Access Compliance Report

Public Rights-of-Way

(Curb Ramps)

Intersection ID: 26030	Main Street: BAYBROOK_LN	Cross Street: REAFIELD_DR	Location: E
ADA ID: E393B13CEE35	Ramp Type: PerpDiag	Initial Pass/Fail: Fail	Overall Compliance: No
Severity Score: 22.5			
Codes/Mitigation Info/Possible Solution		Field Measurements/Component Compliance

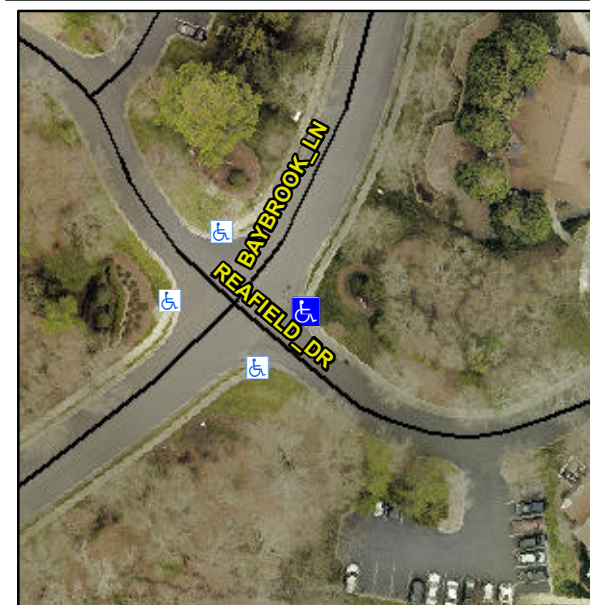
Not Found, R304.5.1, R304.2.2, R304.5.3

Compliance	Description	Data	Compliance	Description	Data
N/A	Ramp Length (in)	47.0	No	Ramp Slope (%)	9.6
No	Ramp Width (in)	47.0	No	Ramp XSlope (%)	5.0
N/A	Flare Type LT	N/A	N/A	Flare Type RT	N/A
N/A	Flare Slope LT (%)	N/A	N/A	Flare Slope RT (%)	N/A
N/A	Flare Traversable LT?	N/A	N/A	Flare Traversable RT?	N/A
N/A	Landing Length (in)	N/A	N/A	DWS Provided?	N/A
N/A	Landing Width (in)	N/A	N/A	DWS Contrast?	N/A
N/A	Landing Slope (%)	N/A	N/A	DWS Length (in)	N/A
N/A	Landing X Slope (%)	N/A	N/A	DWS Full Width?	N/A
N/A	Landing Curb? (Y/N)	N/A	N/A	DWS Offset (in)	N/A
N/A	Shared Landing?	N/A			
N/A	Gutter Ponding?	N/A	N/A	Gutter Slope (%)	N/A
N/A	Gutter Lip Ht (in)	N/A	N/A	Gutter X Slope (%)	N/A
N/A	Painted X Walk1?	No	N/A	Painted X Walk2?	No
	X Walk 1 Direction	To NW		X Walk 2 Direction	To SW
N/A	X Walk 1 Width (in)	N/A	N/A	X Walk 2 Width (in)	N/A
	X Walk 1 Slope (%)	1.5		X Walk 2 Slope (%)	0.9
	X Walk 1 X Slope (%)	1.5		X Walk 2 X Slope (%)	1.0

Remove & Replace Curb Ramp With Two New Directional Ramps or Equivalent.
